Memo

Date: February 26, 2020

Re: Dewey East Development – Detailed Site Plan (DSP-19050) Discussion and Action

Exhibit 3

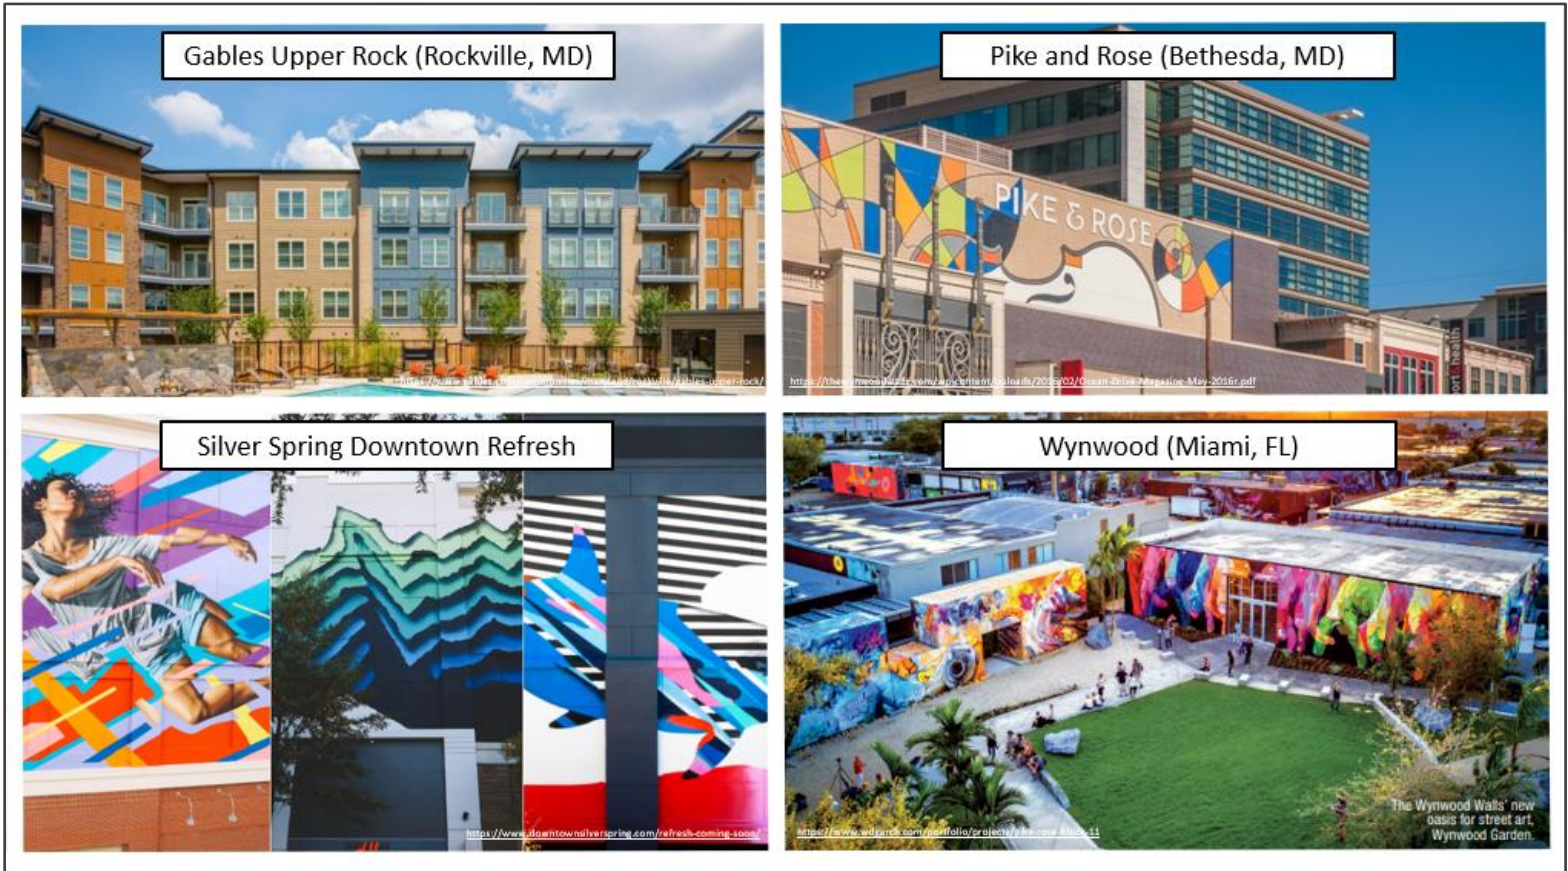
5. The Planning Committee recommends the applicant continue to work with City Staff on developing an appropriate color palette and look at the architecture and art of the following projects as example for the Dewey Parcel 5 development:

- a. Gables Upper Rock (Rockville, MD)
 - b. Pike and Rose (North Bethesda, MD)
 - c. Downtown Silver Spring Refresh Project (Silver Spring, MD)
 - d. Wynwood (Miami, FL)

Pictures of the reference projects and developments suggested by the Planning Committee can be found in Exhibit 3.

Exhibit 4

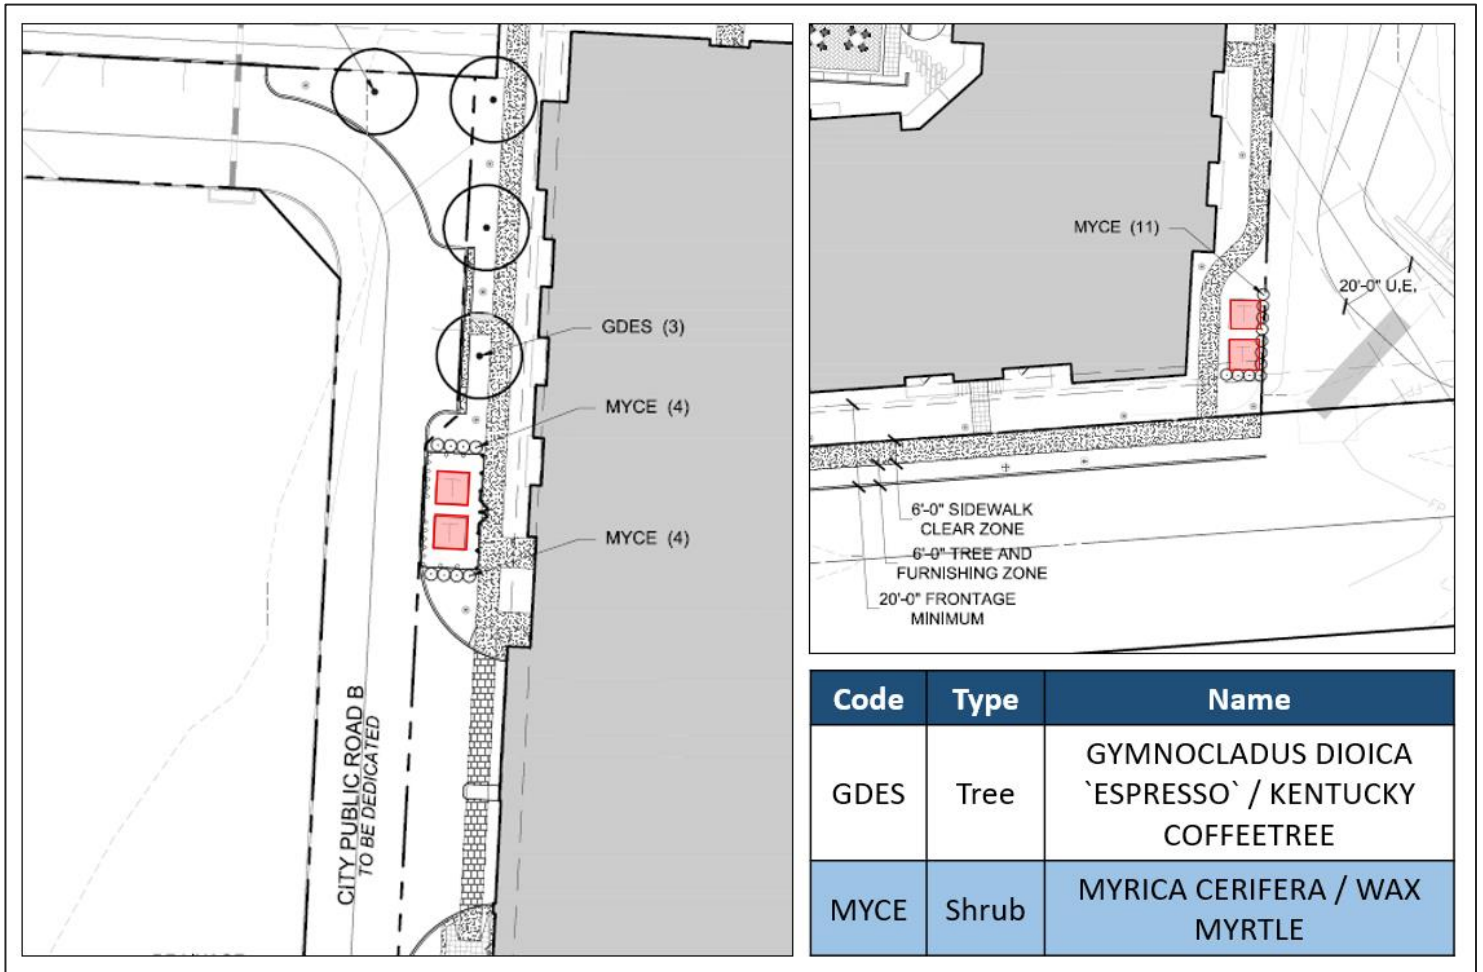
City Staff recommends all transformers associated with this development be installed subgrade, consistent with policy guidance per the Prince George's Plaza TDDP. There are adequate design alternatives available to the developer to accommodate subgrade transformers. Subgrade transformers are more secure, visually appealing, and aligned with the intent of the TDDP than above-grade transformers.

The locations of the applicant’s proposed screening devices can be seen in Exhibit 4. The locations of the transformers can be seen outlined in red.

Taking the applicant’s proposed screening in mind, City Staff still believes that all transformers should be underground. There is sufficient evidence within the TDDP to support placing the transformers subgrade in order to best promote a pedestrian-friendly Downtown Core. The Transit District Development Plan is very clear in its intent for utilities to be placed underground whenever possible. Excerpts from the TDDP that support this claim can be found below:

1. All transformers associated with this development shall be installed subgrade.
2. The proposed retail space shall have a fenestration height of 14' and build-to-line within the 25' maximum depth and 20' minimum depth required in the Transit District Development Plan.

Exhibit 5

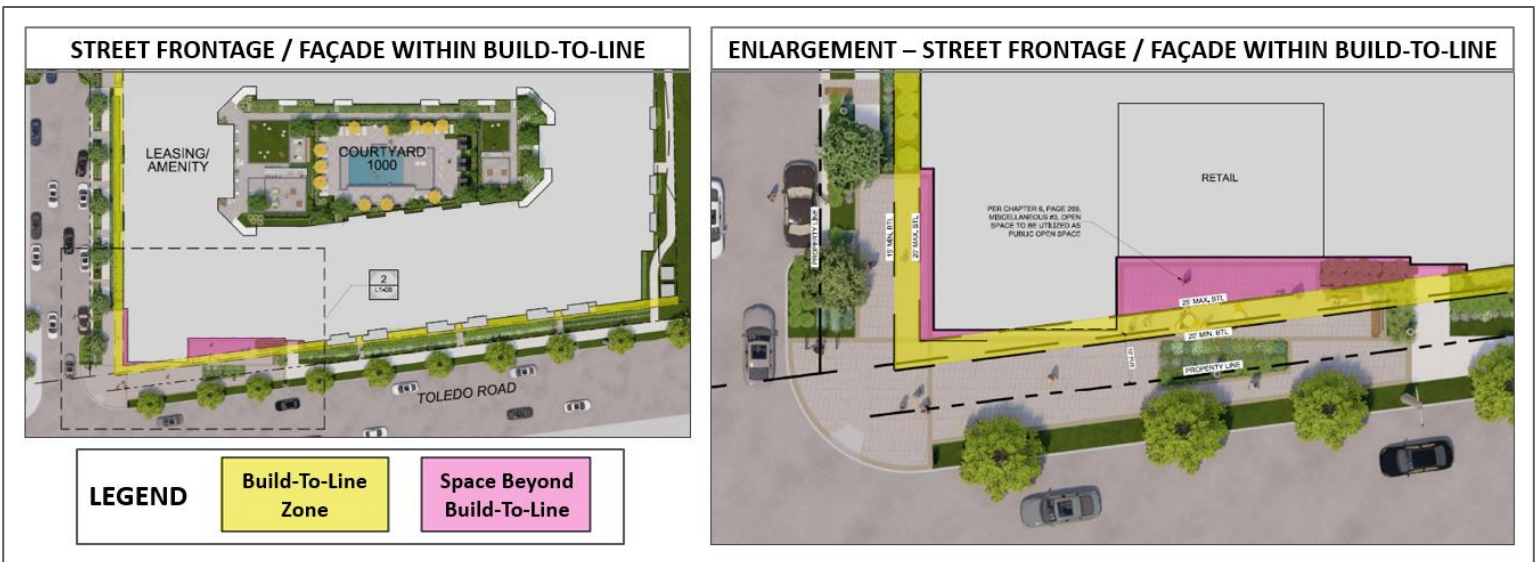
3. *Requesting an extension from the required build-to line (BTL) of 25' for 39% of the building fronting Toledo Road. Requesting an extension from the required build-to line of 20' for 7% of the building fronting the new "B" street running parallel to Belcrest Road. Requesting 4' extension from the required build-to line of 25' for the stoops present along Toledo Road.*

City Staff is amenable to the applicant's build-to-line extensions (except for the proposed retail space), as they are minimal and add visual interest to the development. Exhibit 5 provides a visualization of the applicant's proposed extension from the BTL.

1. The City supports of the applicant's request for a departure from the design standards, specifically the request for 9' x 18' universal sized parking spaces within the proposed parking garage structure.
2. The City supports the applicant's requested build-to-line extensions, except for the proposed retail space.
3. The City supports the applicant's proposed location for the lobby entrance at the corner of Toledo Road and Public Road B."

Exhibit 7

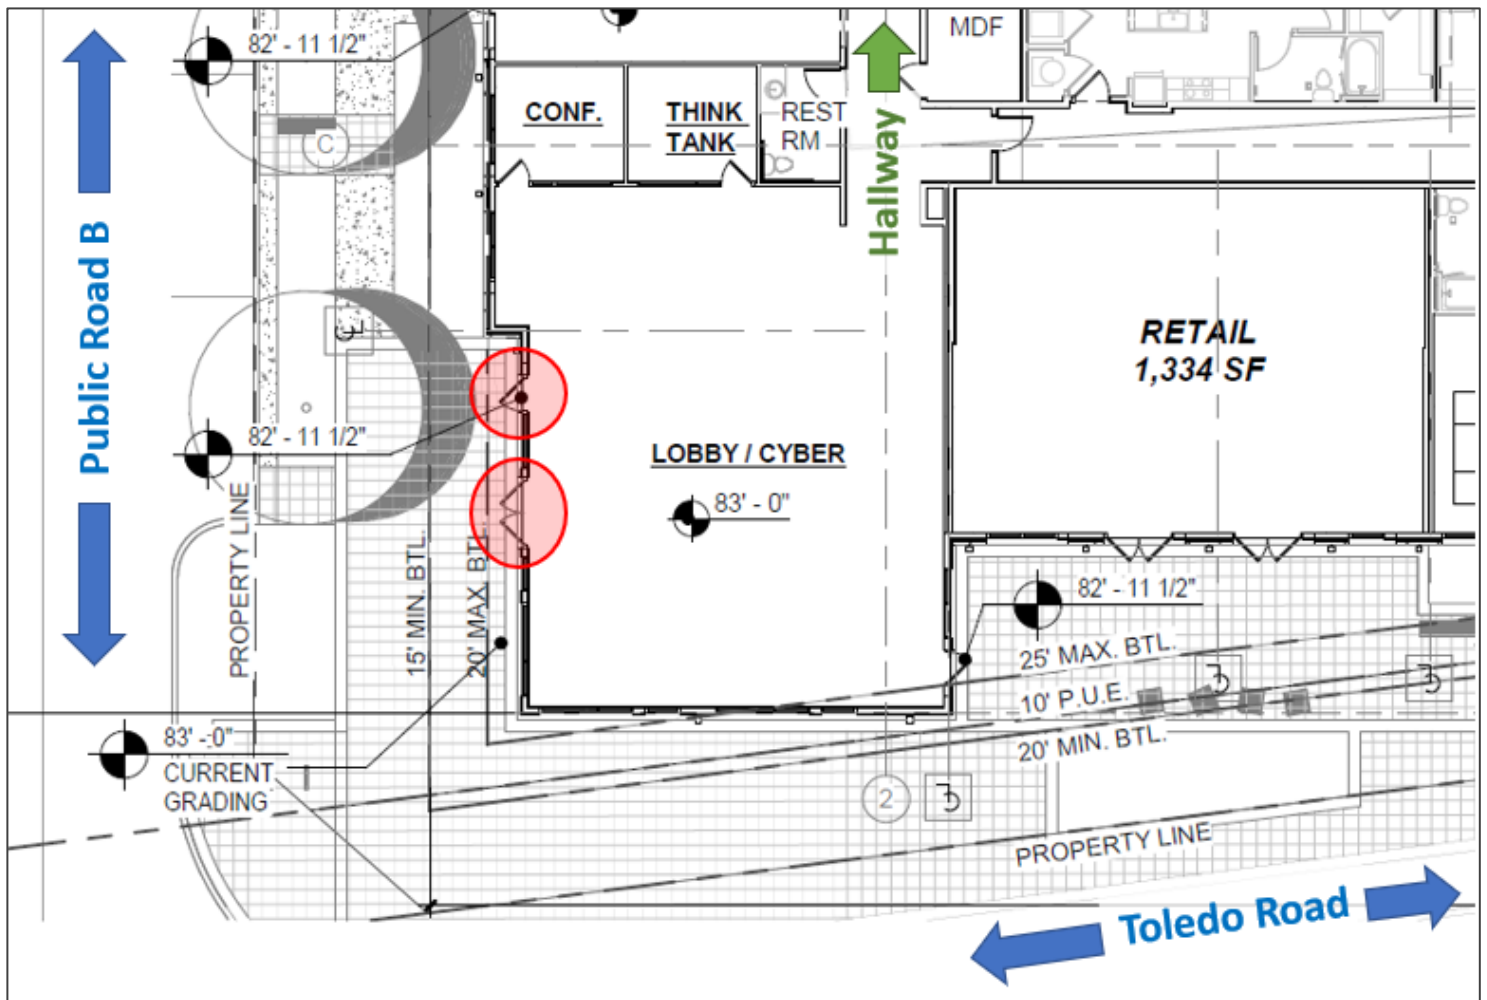
7. Requesting the entrance of the apartment building front Public Road B as opposed to an "A" Street (Toledo Road).

According to the TDDP, if a building fronts on both A and B streets, Pedestrian Street, or Promenade, its primary entry shall be located on the A Street (TDDP, pg. 210). This development fronts both Toledo Road and Public Road B. As Toledo Road is a Downtown Core A Street, the primary entrance (leasing office/lobby entrance) of the proposed mixed-use building should front Toledo Road as opposed to Public Road B (TDDP, pg. 265).

In order to better conform to the TDDP, the applicant has amended their plan to include the building's lobby on the corner of Toledo Road and Public Road B, with an entrance fronting on Public Road B. The TDDP states, "all street-defining buildings on corners should orient main entrances towards the corner" (TDDP, pg. 267). A visualization of this configuration can be found in Exhibit 7. The entrances are circled in red.

Exhibit 8

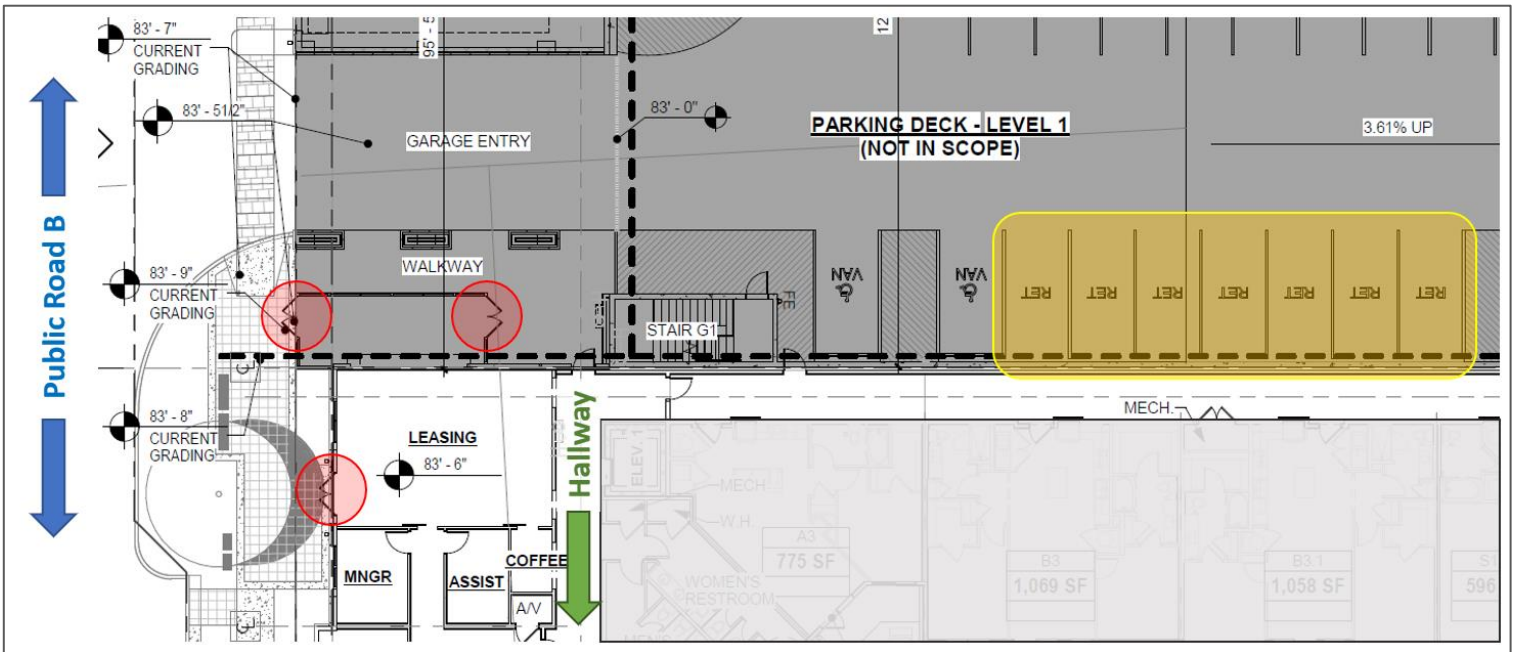
In the applicant’s revised plan, the leasing office remains next to the garage entrance along Public Road B. The applicant wants the leasing office to be located next to the garage because the reserved parking spaces for future residents are on the ground floor of the structured parking garage. The lobby at the corner of Toledo Road and Public Road B and the leasing office next to the garage are connected by an interior hallway. Exhibit 8 demonstrates the location of the leasing office. The entrances to the leasing office are in red, the reserved parking spaces are circled in yellow, and the hallway is indicated in green.

City Staff agrees that the building’s main entrance (in this case, the lobby entrance) must reside at the corner of Toledo Road and Public Road B to best activate the streetscape and help avoid confusion for visitors. City Staff is agreeable to having the leasing office adjacent to the garage in order to provide parking to potential renters. If individuals enter through the lobby, ideally building complex staff will be able to direct individuals to the leasing office internal to the building using the connecting hallway.

City Staff is also amenable to moving the leasing office to the currently proposed retail space fronting “A Street” Toledo Road. In this instance, the applicant would request the removal of the commercial element from the development and the leasing office would go in its place. Under this scenario, the applicant would no longer need to request a modification to the fenestration height, as the space would no longer be commercial in nature. A lower fenestration height would enable the applicant to retain the residential units on the second floor above.

Exhibit 9

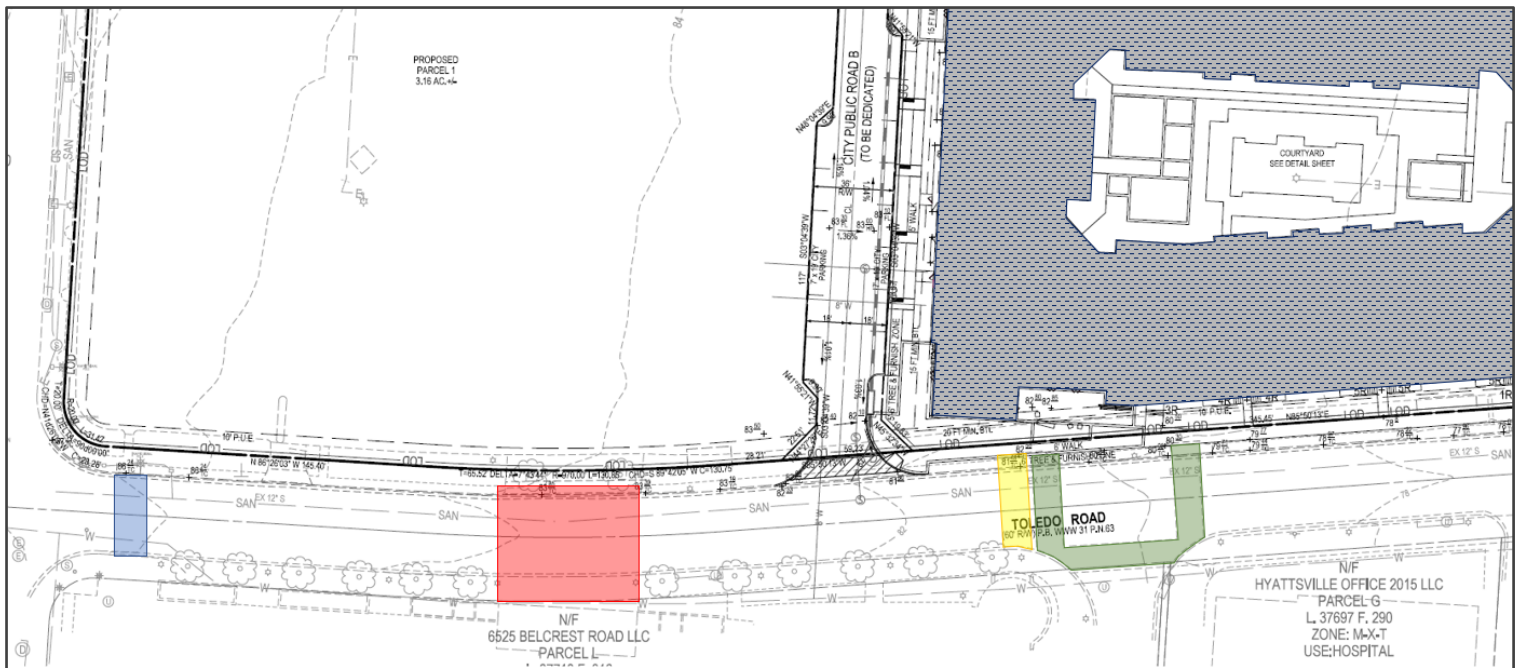
In addition, City Staff is recommending the applicant improve the western leg of the existing crosswalk on Toledo Terrace adjacent to America Boulevard. This right-of-way infrastructure is imperative to maintaining the connection between the development and the Prince George's Plaza Metro Station, as well as the amenities present in University Town Center. The southern leg of the crosswalk does not touch the boundaries of the Parcel and therefore is not within the purview of this application. It is City Staff's opinion that the crosswalk at America Boulevard only needs a western and southern leg, as the volume of use and configuration of surrounding buildings does not call for an eastern leg.

In addition, Staff believes the mid-block crossing on Toledo Terrace connecting to Parcel 1 is no longer necessary; it is primarily used by individuals who utilize the existing parking lot, which will be eliminated as part of this development. This mid-block crossing is unnecessary as individuals on Parcel 1 can either utilize the crosswalk adjacent to Belcrest Road or the crosswalk adjacent to America Boulevard.

The location of the crosswalks adjacent to America Boulevard can be seen in green on Exhibit 9. The mid-block crossing, providing access from Parcel 1 is outlined in red. The existing crosswalk on Toledo Road adjacent to Belcrest Road is outline in blue. The improved, western leg of the crosswalk can be seen in yellow. The improved crosswalk shall include a non-masonry material with a preference of either stamped concrete or 'poured in place' synthetic product to ensure long-term durability of the crosswalk.

3. The applicant shall dedicate space for regular loading and delivery services within the structured parking garage.
4. The applicant shall improve of the western leg of the existing crosswalk on Toledo Terrace adjacent to America Boulevard, as this right-of-way improvement is imperative to maintaining the connection between the proposed development and the Prince George's Plaza Metro Station, as well as the amenities present in University Town Center.

Exhibit 10

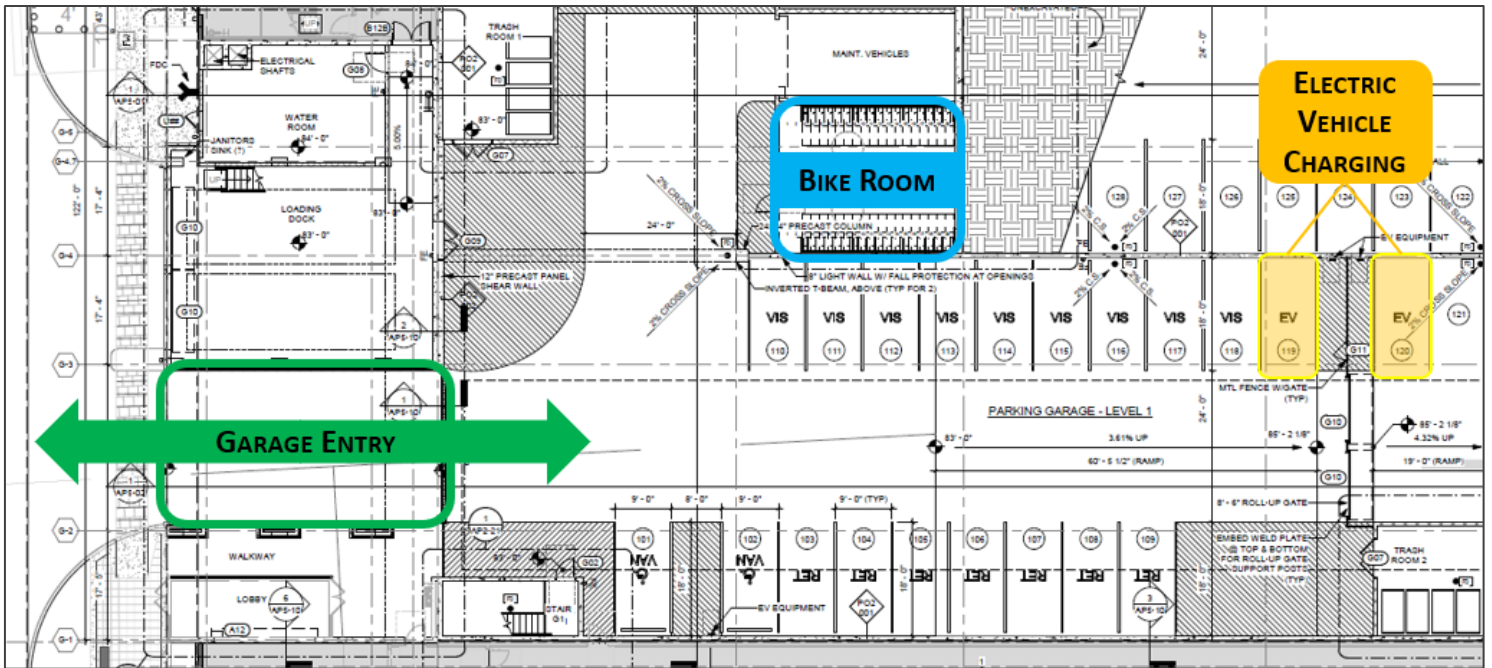
In order to further promote bicycle use in the City, City Staff recommends a minimum of two (2) inverted-U shaped bike racks be installed in front of the leasing office and at least two (2) inverted-U shaped bike racks be installed adjacent to the proposed retail space. To ensure the building has adequate bicycle parking capacity for its residents, City Staff recommends a 1:1 ratio of bicycle parking spaces to vehicle parking spaces. This area within the garage should be dedicated to bicycle storage solely, and not used for any other storage purposes. Exhibit 10 demonstrates the applicant’s proposed bicycle storage configuration and capacity within the structured garage, as well as the location of electric vehicle charging stations on the first floor of the garage.

5. The applicant shall install at least two (2) inverted-U shaped bike racks in front of the leasing office and at least two (2) inverted-U shaped bike racks in front of the retail space. The applicant shall accommodate a 1:1 ratio of bicycle parking spaces to vehicle parking spaces.
